STATE OF CONNECTICUT
CONNECTICUT SITING COUNCIL

DOCKET NO. 441

HOMELAND TOWERS, LLC and NEW CINGULAR WIRELESS, PCS LLC (AT&T)
RESPONSES TO SITING COUNCIL PRE-HEARING QUESTIONS SET I

AT&T Proposed Coverage at Washington, CT with S2417 @ 116' AGL

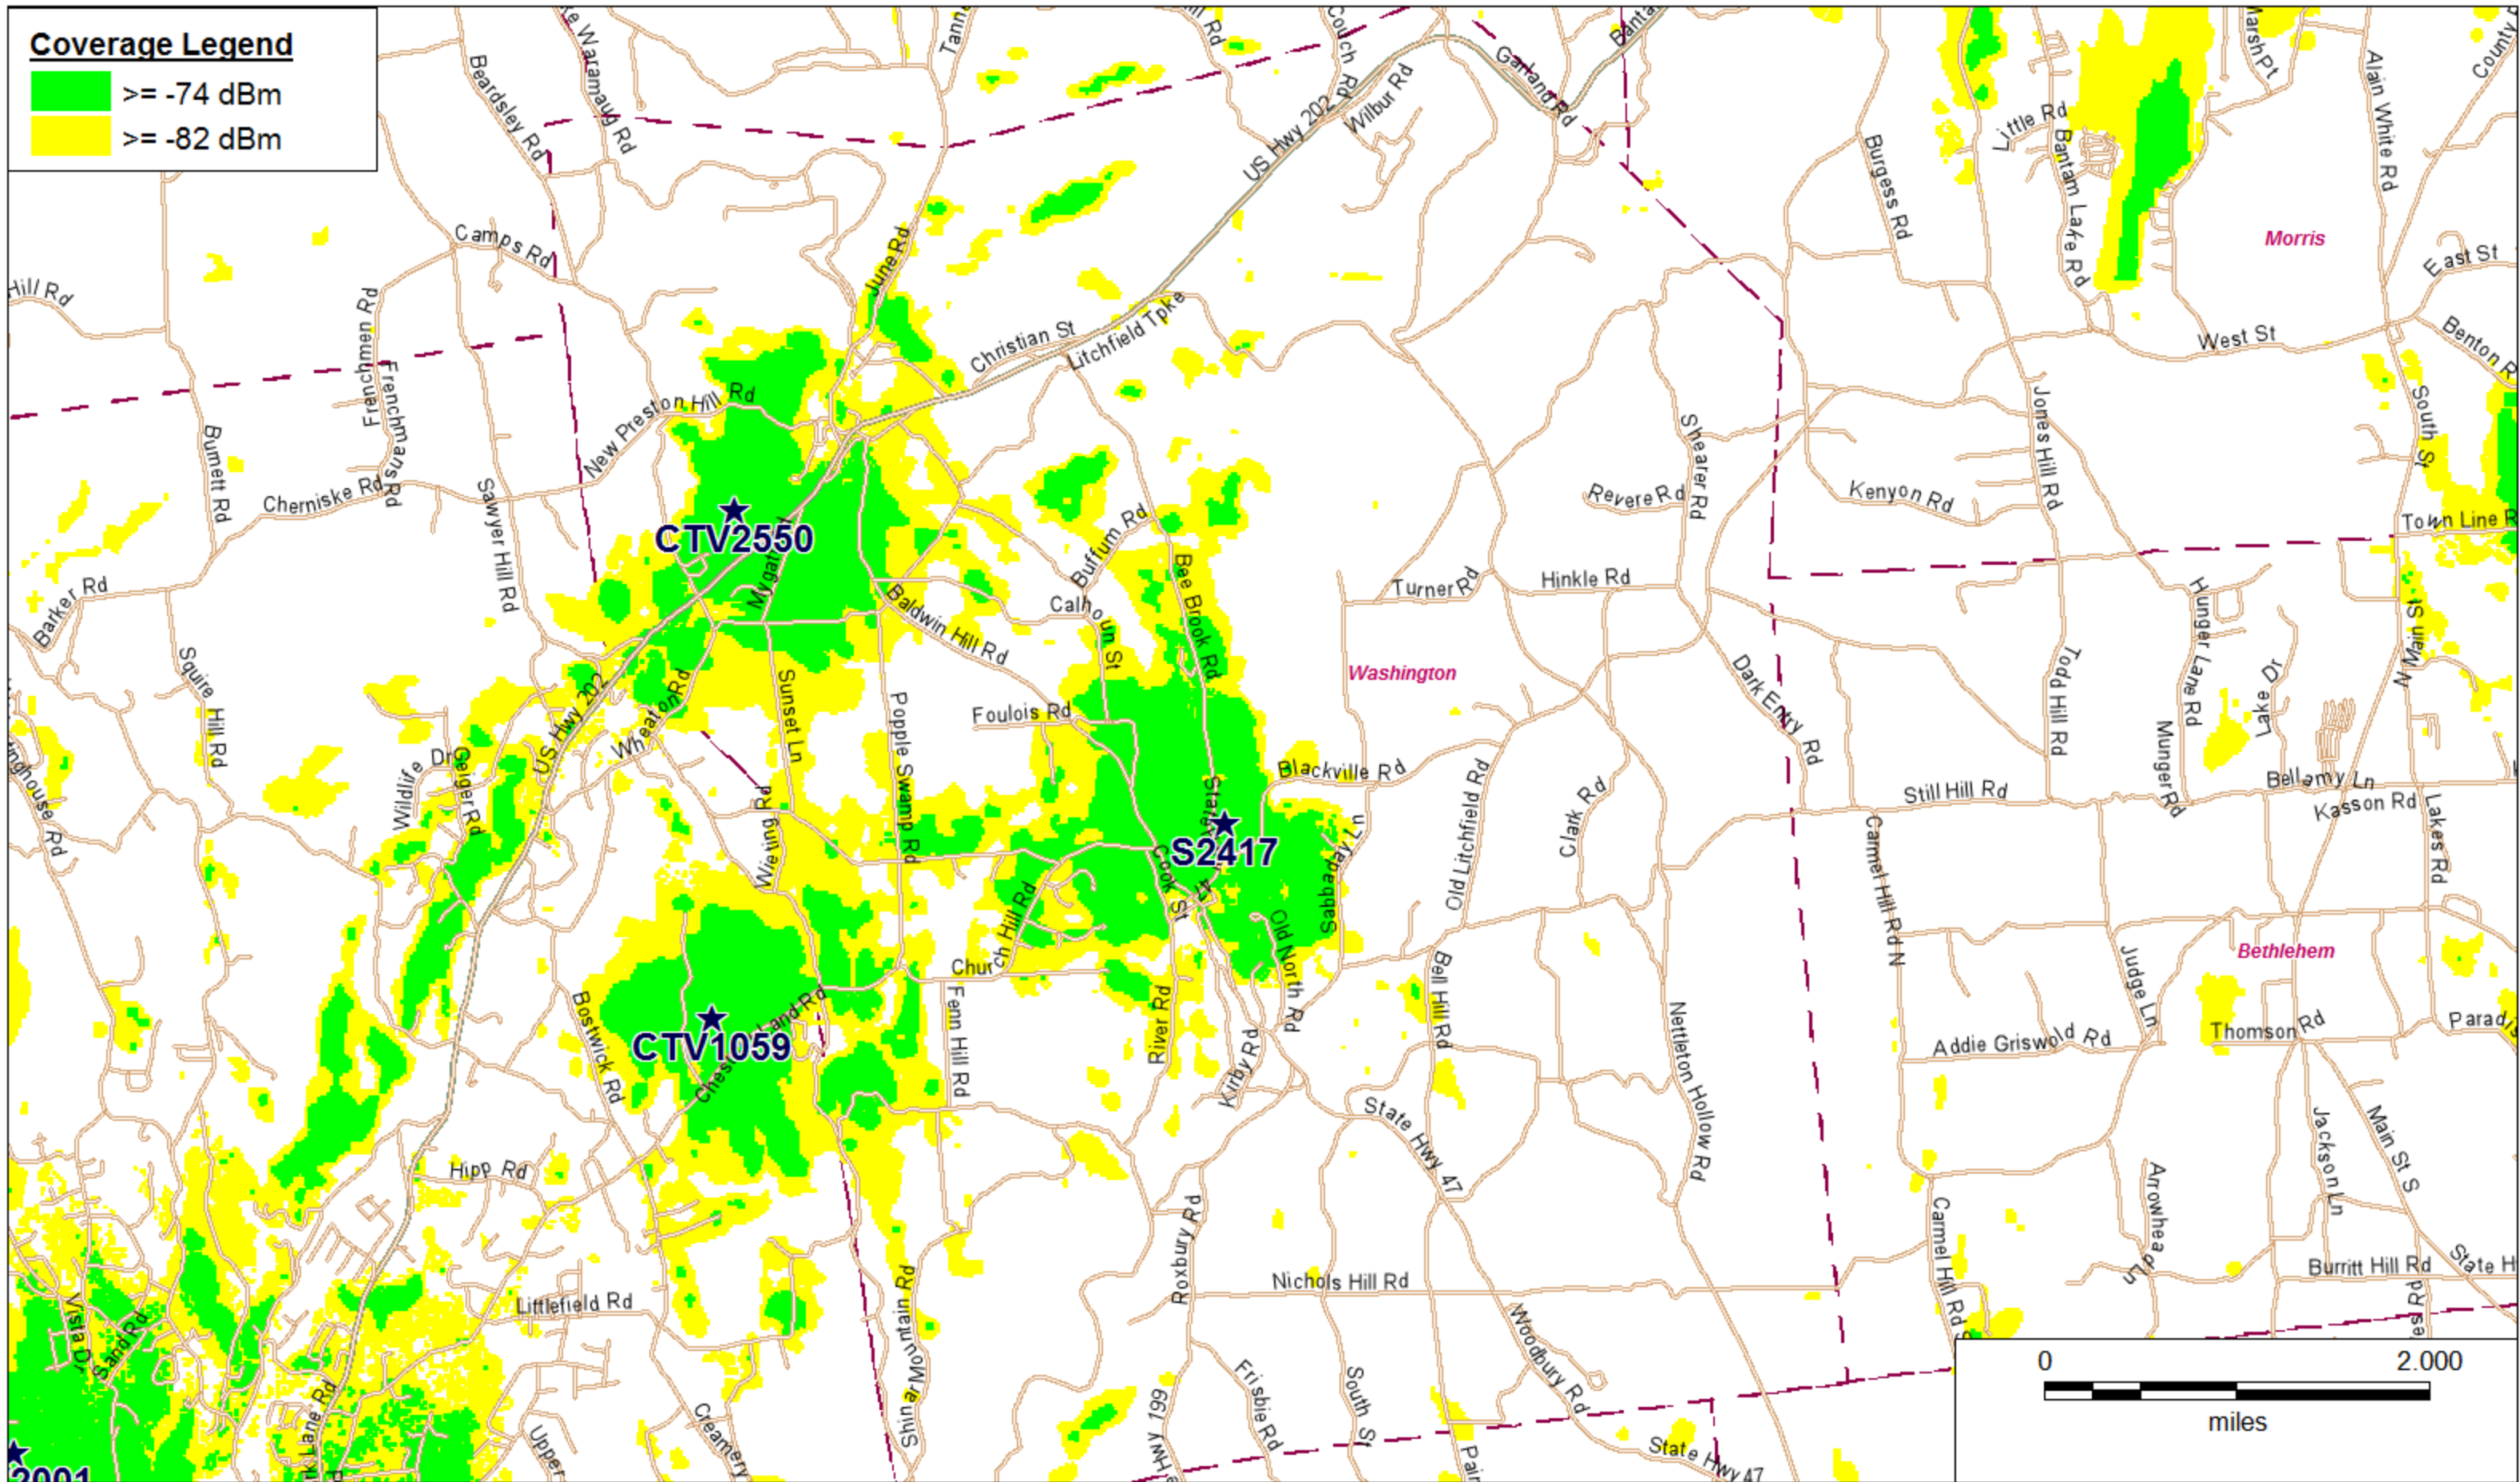
- A9. Yes, as in A6, above, these plots were generated using AT&T's propagation tool, and the prediction was generated at 850 MHz.
- Q10. What is the lowest feasible height at which AT&T's antennas could fulfill the coverage objectives from the proposed facility? What problems would result if AT&T were to install antennas at a lower height? Submit a propagation map showing the coverage at ten feet below this height.

- A10. The lowest height acceptable to AT&T would be 126' AGL. If AT&T were to install antennas at lower heights, some areas of substandard service in the target area would begin to appear where customers would experience dropped calls or data sessions, increased latency, lower transmission speeds or unintelligible communication. For AT&T, a lower overall tower height would impact future tower siting locations and heights of future towers, particularly in areas moving out of Washington Depot to the north, east and south. Please see Attachment 1. Moreover, a tower of lesser height above the tree line would negatively impact the ability for other carriers to collocate on the tower. Indeed, as revealed during the course of the municipal consultation, other carriers have expressed interest in serving the area and consultations with the town identified the Town's garage site as the only viable alternative in the area. See, Application Attachment 7.
